Sweeper application

ARCHER HUMPHRYES ARCHITECTS

6. Extension of balcony to DJ booth

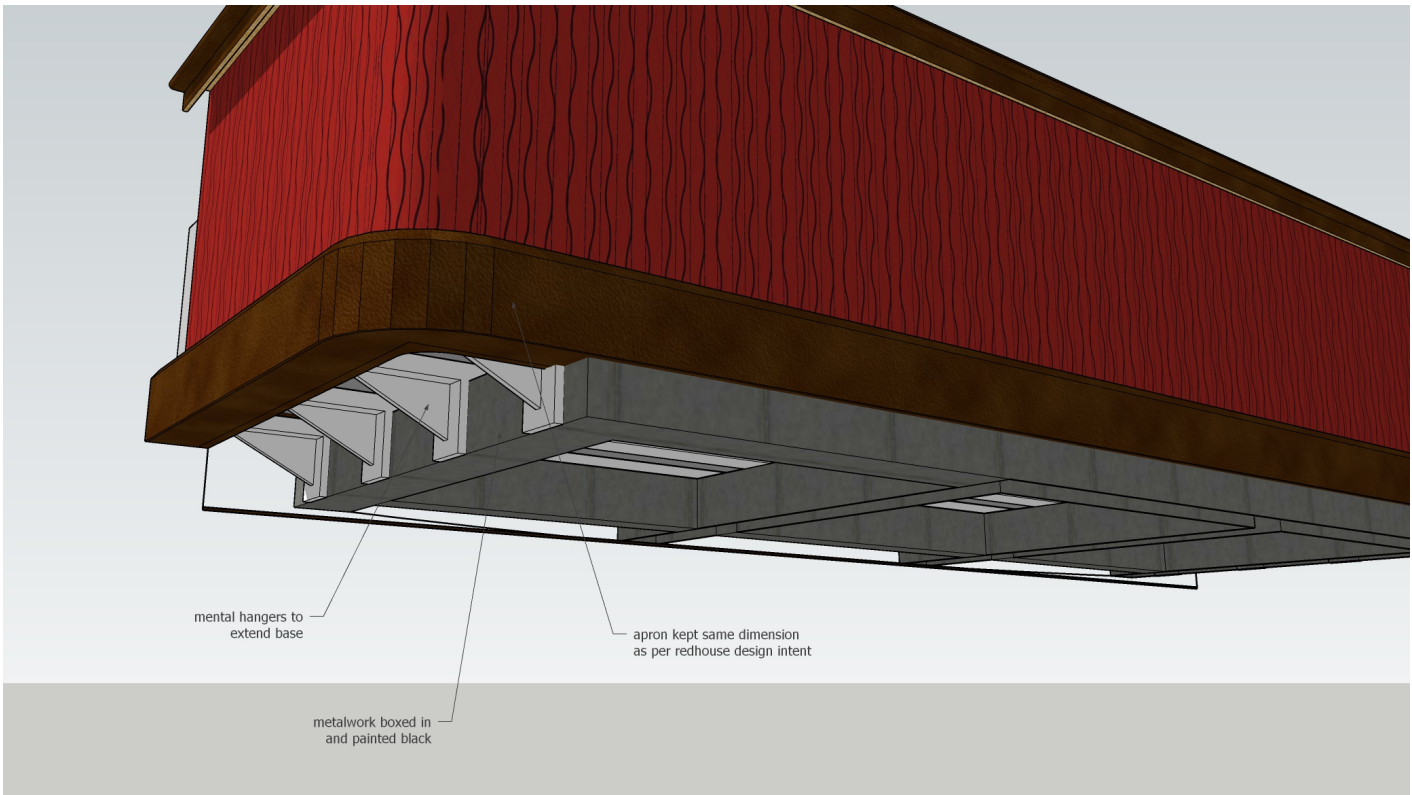
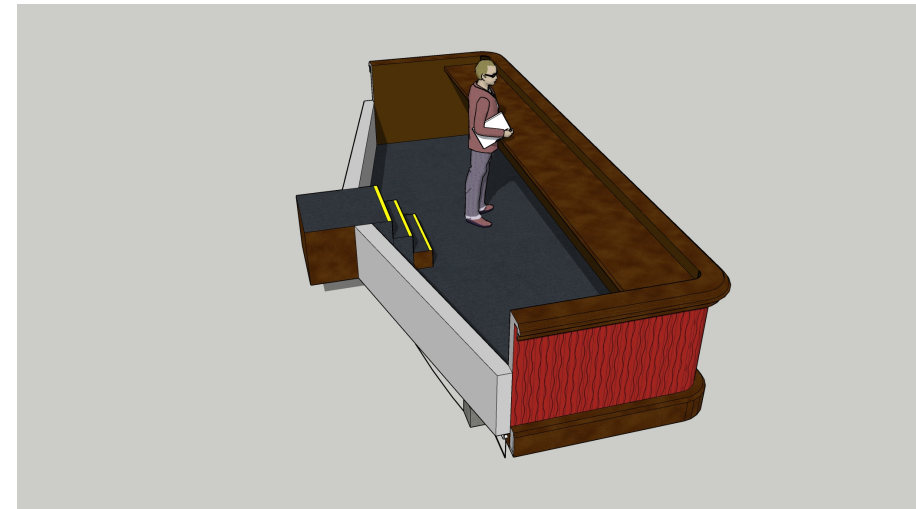
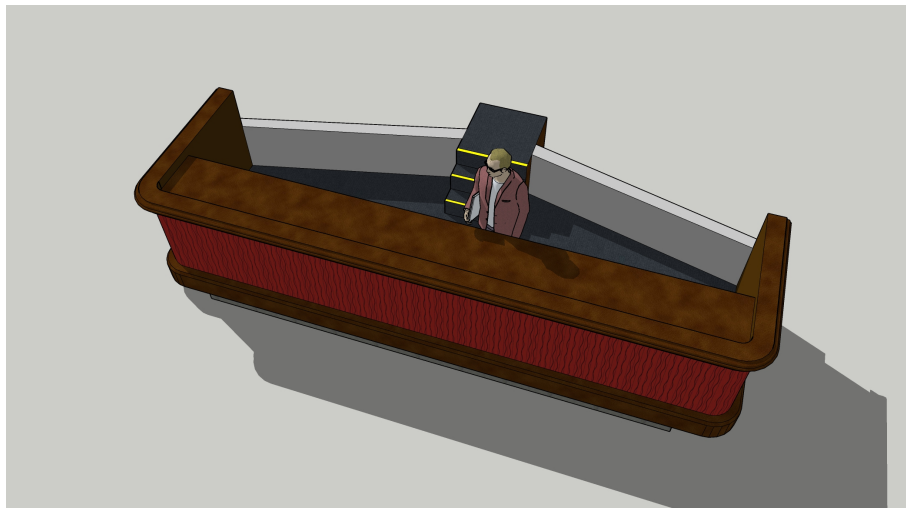
Extension of balcony to DJ / Sound booth.

It has been required to extend the DJ / Sound booth for current specification of equipment that will be required in this area. The light gray bracket has been designed with the structural engineer and can be attached to the existing metal frame seen above in dark gray.

7. Opening within basement as a
Secondary means of escape

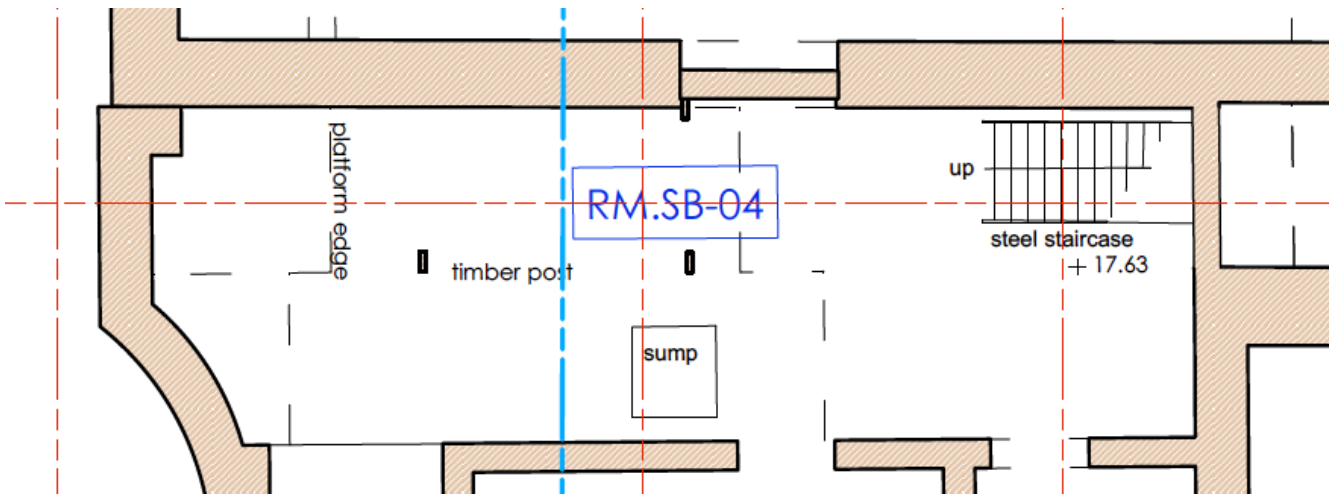
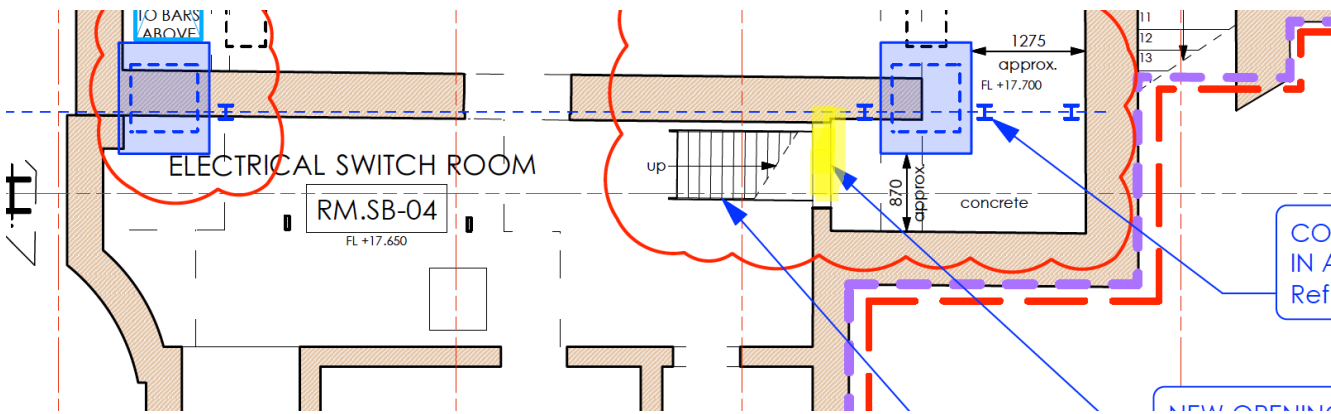
New opening in the basement to be within regulations.

New opening / and reinstatement of an existing stair in basement areas. It is a statutory requirement to have two exists in an electrical switch room, we are therefore asking for permission to open a second door into the switch room. The opening will be below the existing steel stair highlighted below in yellow. The steel stair will be kept and relocated.
